RESPONSE TO SUBMISSIONS

LINDFIELD LEARNING VILLAGE (SSD 16_8114)

14 JUNE 2018
SA6386
FINAL
PREPARED FOR NSW DEPARTMENT OF EDUCATION

Figure 1 – Site Boundary Plan

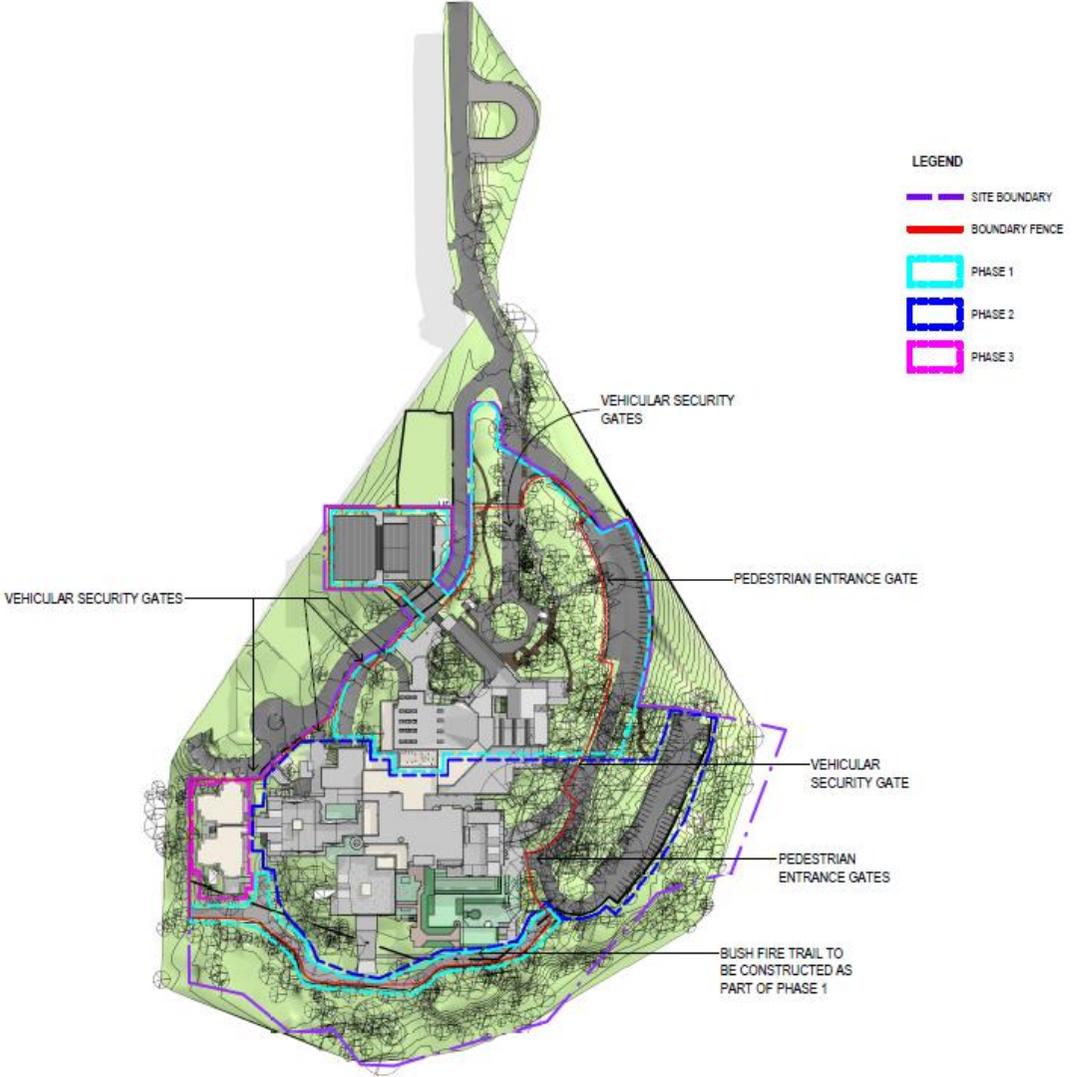
To address submissions from Council and RFS (and subsequent engagement) and to ensure a school can open in time for Term 1 2019, the proposal has been amended as follows:

- Removal of the childcare centre from the SSD application; and
- New phasing within Construction Stage 1, detailed below and shown in **Figure 1**. Construction Stage 2 remains as previously proposed.

The site boundary encompasses Lots 2 and 4 in DP1151638 as illustrated in **Figure 1**. These land parcels are owned by DoE and accommodate the proposed works as follows:

- Lot 2 DP1151638: Internal and external alterations to the existing building, parking alterations.
- Lot 4 DP1151638: Covered outdoor learning area (COLA) associated with Construction Stage 2 and fire trail to the south of the existing building.

Figure 2 – Site plan detailing Phase 1

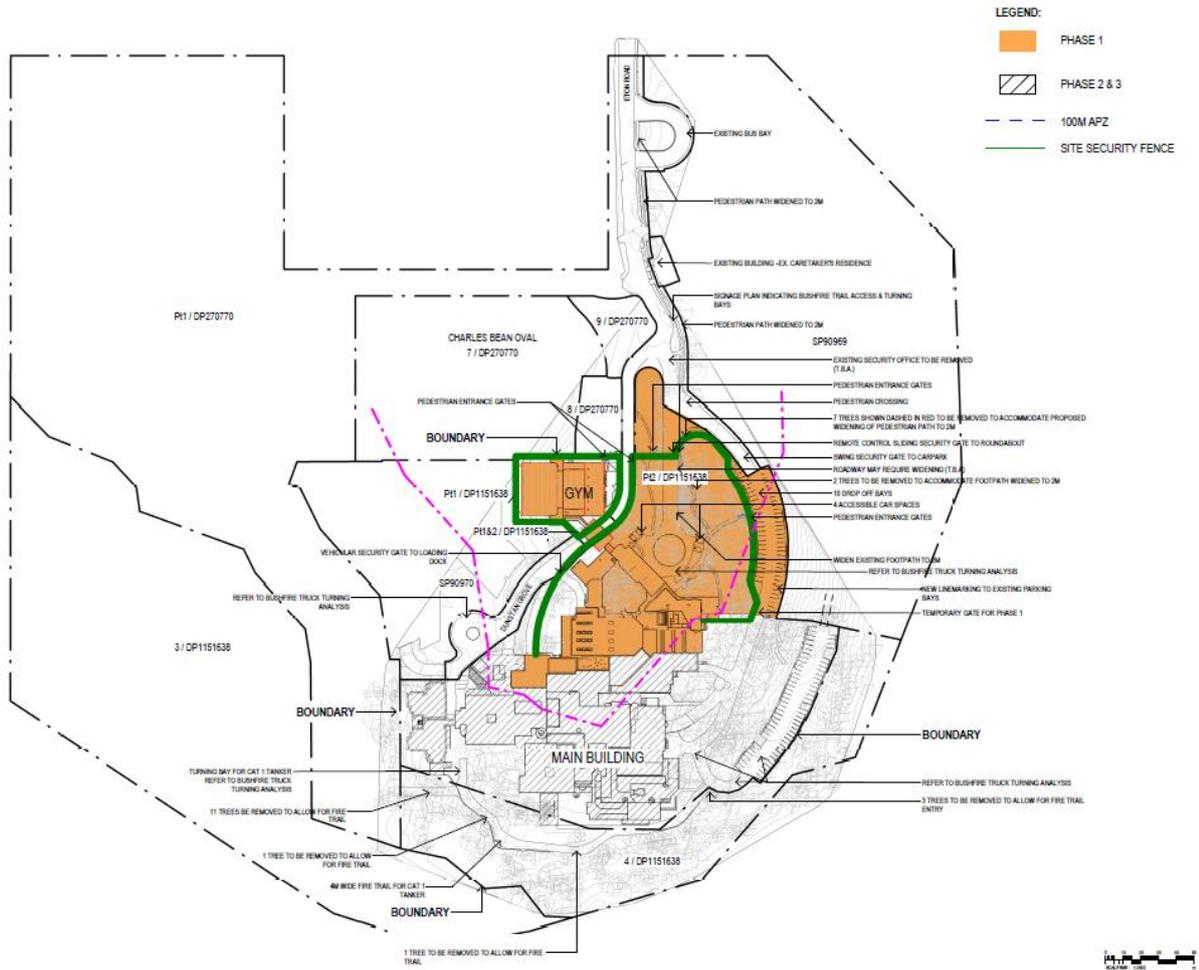
Phase 1 has been designed to satisfy RFS' requirement for a 100m APZ. Phase 1 is illustrated in **Figure 2**.

- Roof addition and screen to the rooftop COLA. The roof structure and screens will be fabricated powdercoated aluminium or pre-painted panels fibre cement or steel.
- New lift overruns.
- New fire isolated stair extension.
- Replacement of all asbestos affected windows and glass doors with new toughened glass windows and doors.
- 4m wide fire trail to the south of the building. The track will be constructed in part of concrete and in part of Turfpave XD (soil and sand mix with artificial turf).
- Upgrades to the footpaths, parking and drop-off/pick-up area.

The proposed external alterations are detailed in the building elevation plans (Drawing Nos. DA-300 and DA-301) at **Appendix A**.

Figure 3 – Proposed Tree Removal

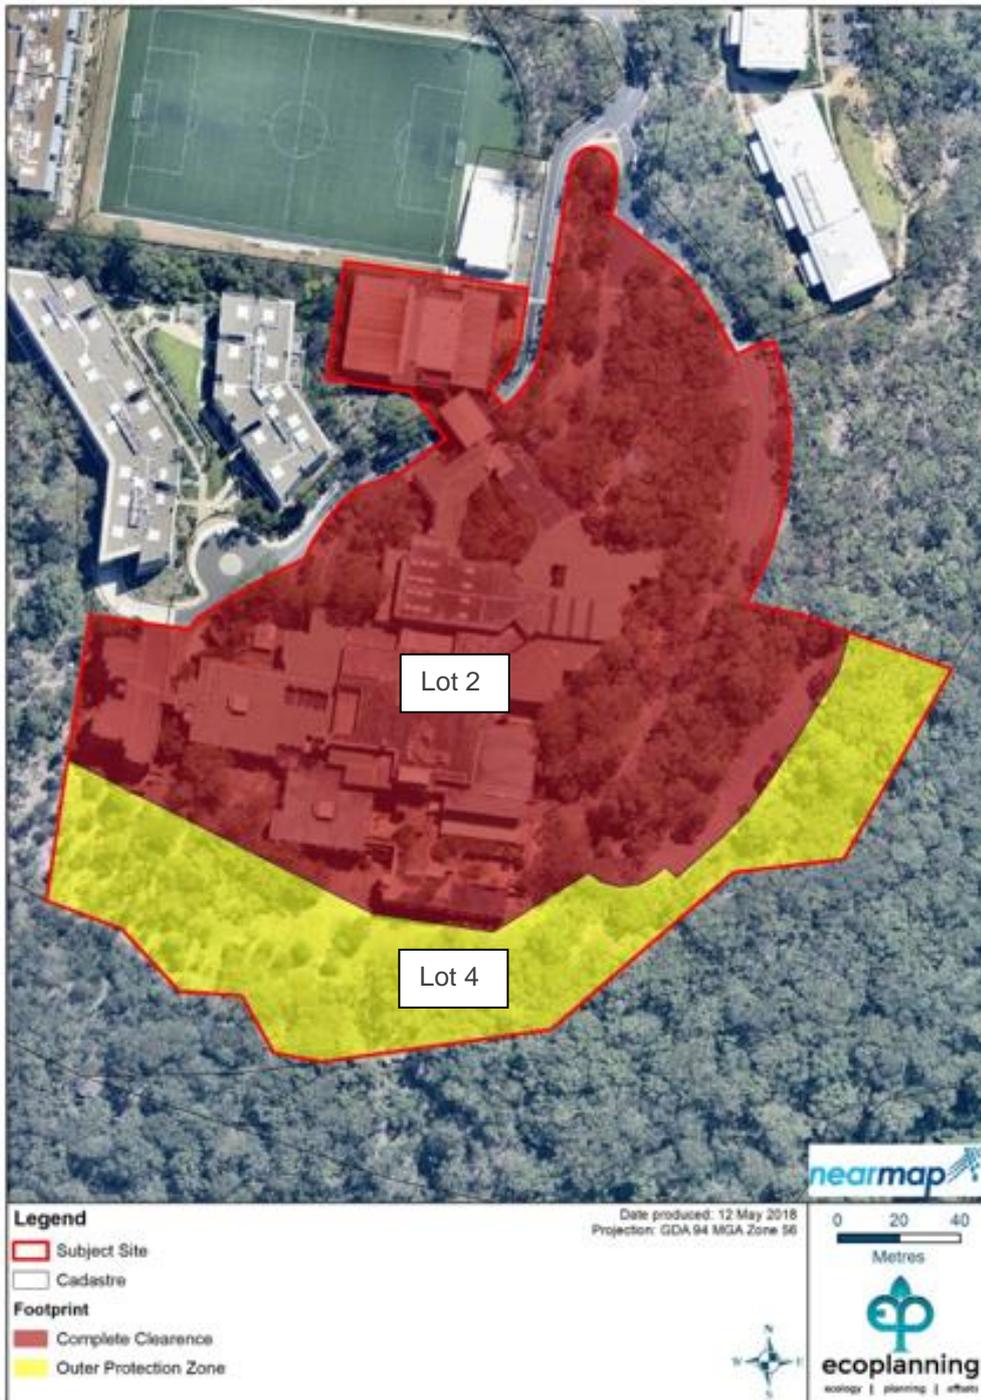
Significant vegetation removal / management is required to create the APZs onsite which has not been reflected in the EIS or accompanying Biodiversity Assessment Report.	The proposed vegetation clearing is addressed in the revised Biodiversity Assessment Report prepared by Ecoplanning.	Appendix L

To establish a 100m APZ, significant tree removal will be required across portions of the site as illustrated in Figure 3. For the purposes of the Biodiversity Assessment (refer **Appendix L**) and to assess the worst-case scenario, complete tree removal within Lot 2 has been assessed (Refer to area shaded red in **Figure 3**). However, it is expected that some trees and vegetation will remain, subject to being able to meet the inner protection area standards.

Phase 1 will include new landscaping to the immediate north of the building and roundabout to allow outdoor play by students. The proposed landscaping for Phase 1 is detailed in the Landscape Concept Plan at **Appendix B**.
